Response to FCC Correspondence, Reference Number: 128308

The responses below follow a reprint of your questions from the email dated 7/10/2012 in reference to our filing under FCC ID: AS5ONEBTS-16 and Timco Job # 386UC12.

From: tei@timcoengr.com [mailto:tei@timcoengr.com]
Sent: Wednesday, July 11, 2012 5:01 PM
To: Pillmeier, Rudolf J (Rudy); Farina, Michael P (Michael); Majkowski, Walter S (Steve)
Subject: Request for additional info - ALCATEL-LUCENT USA, INC. - FCC ID: AS5ONEBTS-16 - JOB #: 386UC12

QPSK Channel 30 Modulation data.

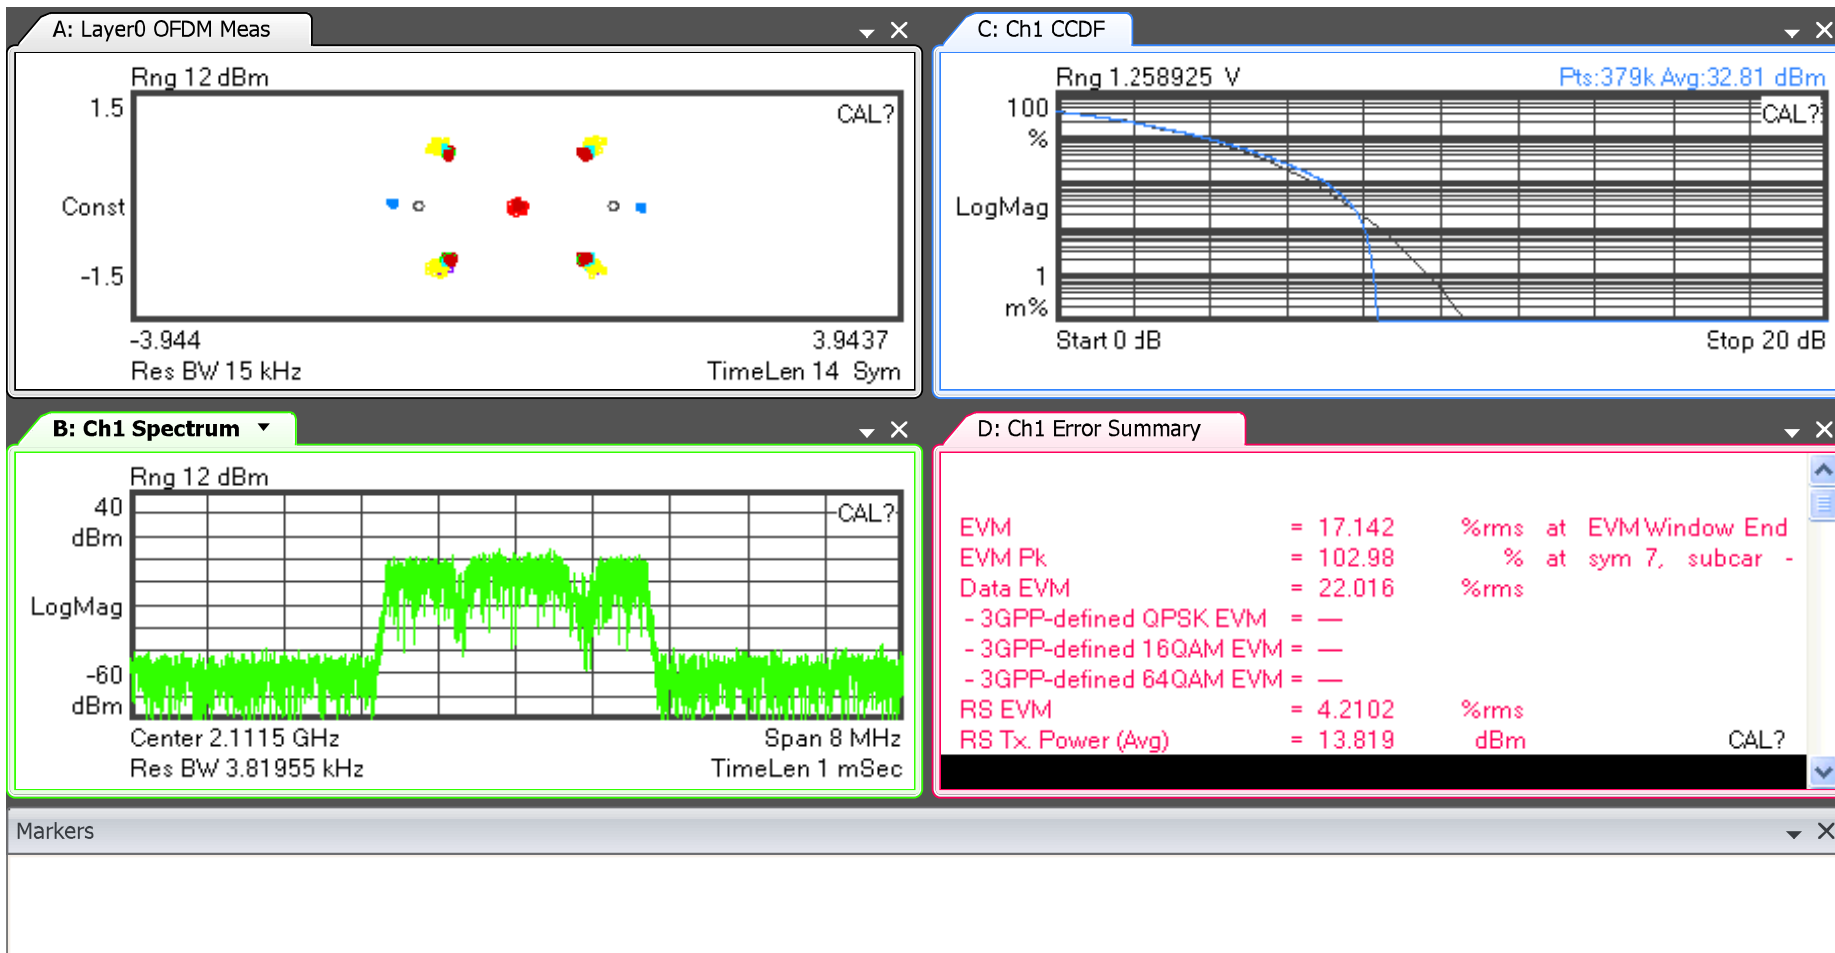
1. It appears that, based on Exhibits 2 and 12, the maximum power output presented is mean/average power. Per 27.50(d)(5), PAR (peak-to-average) ratio should be less than 13 dB if average power is measured. No compliance data can be found in the test report.

The maximum output power presented is mean/average power. Although a PAR measurement is not required in Sections 2.1046 through 2.1057 as specified in section 2.1033, the data was presented as part of the Modulation Data in the subject test report and can be found in Exhibit 13. Specifically Figures 13B, 13C and 13D on pages 9-11, attached below, includes PAR measurement as part of the analysis. The upper right "log magnitude" chart plots PAR for the actual data rate against a standard Gaussian response. The chart indicates that the PAR is approximately 8.2 dB which is well below the required 13 dB. It should be noted that the time stamp at the top right of the overall chart is the Agilent 89600B test system time stamp applied at time of measurement. The files were saved from the instrument in both "Tiff "(B&W) and pdf (color) formats with a white background (for easier printing). The pdf files were then inserted into the MSWord report prior to conversion of the overall report to pdf to reduce file size. This re-pdf'd process seems to have degraded the quality of the power charts that was in the report. Attached below are higher resolution copies of the three original source data files that were in the report documenting PAR performance for QPSK, 16QAM and 64QAM operation.

Modulation and PAR were verified for each of the 11 "Edge of Block" measurement test configurations. At each of the 11 block edges the modulation and PAR was verified for QPSK, 16QAM and 64QAM operation. A total of 33 screen plots were recorded. Three were presented as examples and the compliance of the rest of the data was reported in Exhibit 13. The verification of modulation at every block edge was executed to ensure that the measurement of RF Power (Exhibit 12), Occupied Bandwidth (Exhibit 14) and Conducted Spurious emissions at the Antenna terminal (Exhibit 15) would represent valid performance.
